**SECTION 4.55(1A) – N0013/15 – TWO STAGED COMMUNITY TITLE SUBDIVISION
6 AND 6A ORCHARD STREET; 9 AND 13 FERN CREEK ROAD, WARRIEWOOD**

Reference is made to the abovementioned Development Consent (N0013/15) issued on 25 June 2015 for a two staged community title subdivision.

This Section 4.55(1A) Application is submitted to Northern Beaches Council (formally Pittwater Council), on behalf of Skycorp (the Applicant) in support of a modification to Development Consent N0013/15 (**Appendix 1**) as modified on 12 September 2016 (N0013/15/S96/3) and subsequently on 21 November 2016 (N0013/15/S96/3).

Figure 3. Proposed Stormwater Drainage Plan (Source: Northrop, 2018)

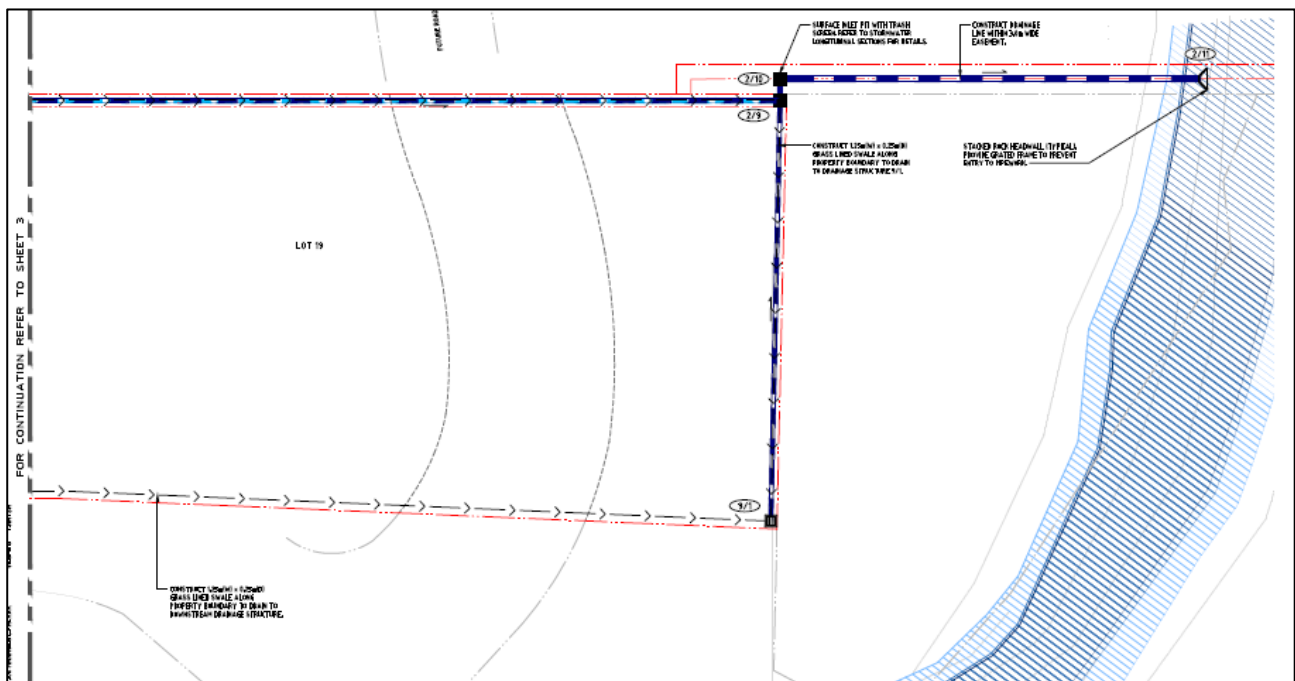
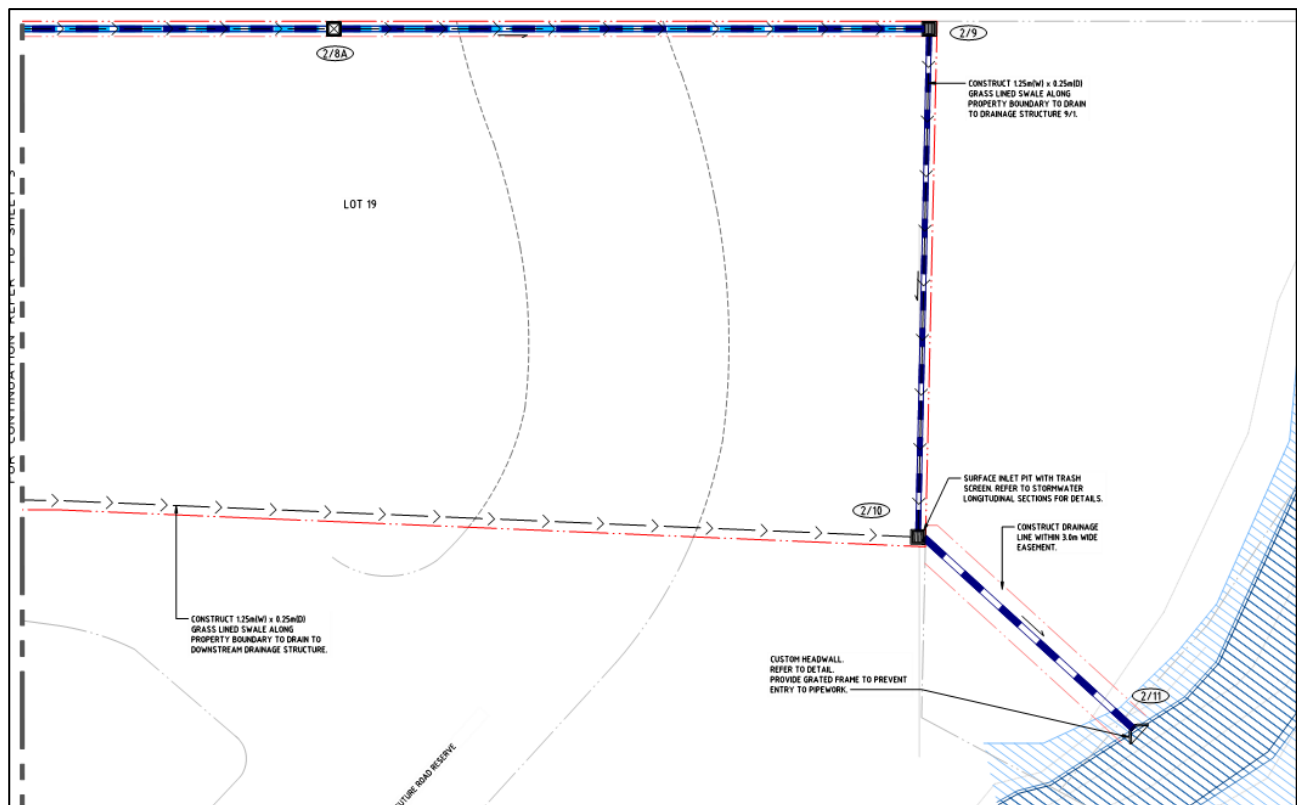
The modification sought to N0013/15 involves the relocation to the approved drainage easement through 9 Fern Creek Road (Lot 5 DP 736961) to 13 Fern Creek Road (Lot 13 DP 1092788). This modification has been proposed as a result of a land ownership swap of the two sites by Frasers Property and the Northern Beaches Council and Council's plan to develop part of 9 Fern Creek Road as a recreational park. Council's preference is to relocate the stormwater easement so that the pipe does not compromise the design of the park or make the future recreational development cost prohibitive.

Given Council will no longer be the owner of 9 Fern Creek Road which is subject to future development by Frasers Property, the approved drainage easement has been requested to be redirected through 13 Fern Creek Road. Owner's consent from Frasers Property for the relocation of the easement through 13 Fern Creek Road has been provided in **Appendix 9**.

The proposal seeks to redirect the previously approved stormwater drainage easement from 9 Fern Creek Road 13 Fern Creek Road. In both scenarios, the easements traverse biodiversity land and are directed into the Fern Creek watercourse. It is important to note that the size and volume of the stormwater pipe remains unchanged as a result of the proposed modification. The proposed redirection of the stormwater pipe requires the removal of five (5) trees as identified in the Arboricultural Report in **Appendix 6**, and shown in the tree survey extract in **Figure 6**.

Figure 6. Tree Survey (Source: Naturally Trees, 2018)

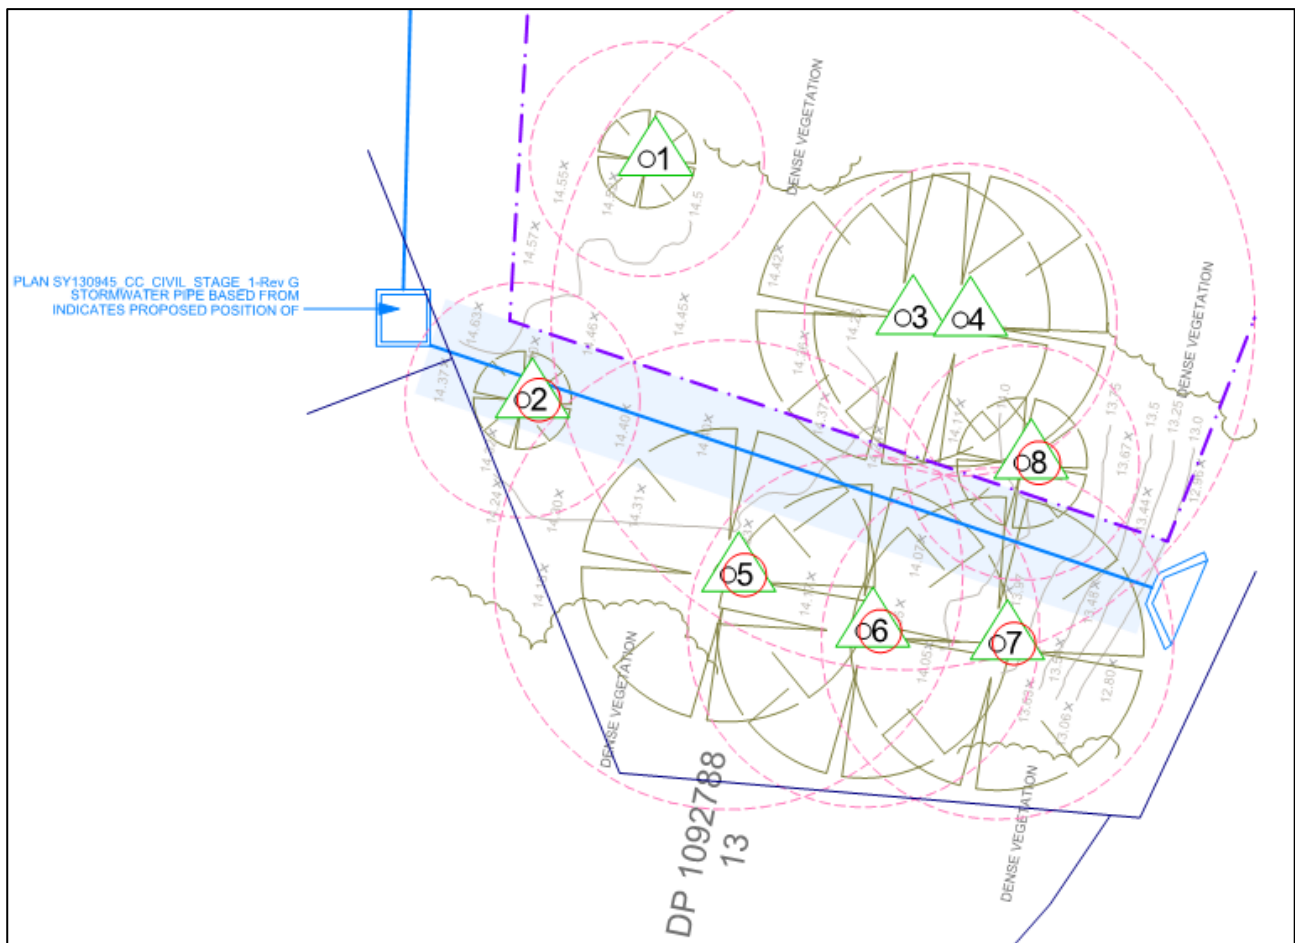
The proposed location of the drainage easement requires the removal of five (5) trees. These trees have been surveyed and assessed by Naturally Trees Arboricultural Consulting as demonstrated in the Arboricultural Report in **Appendix 6**. The trees to be removed (identified as Trees 2, 5, 6, 7 and 8) have been assessed as having moderate to high significance and displaying good health and condition.

The Arboricultural Report also identified three (3) trees to be retained (identified as Trees 1, 3 and 4) which may potentially be affected through disturbance to the TPZs. However, Naturally Trees Arboricultural Consulting concludes that Trees 1 and 4 could be successfully retained without any adverse effects if the appropriate protective measures are properly implemented. Concern is raised in regard to Tree 3 due to the proposed excavation impeding 27% within the TPZ. The developer shall make every effort to retain this tree through the implementation of the appropriate measures.
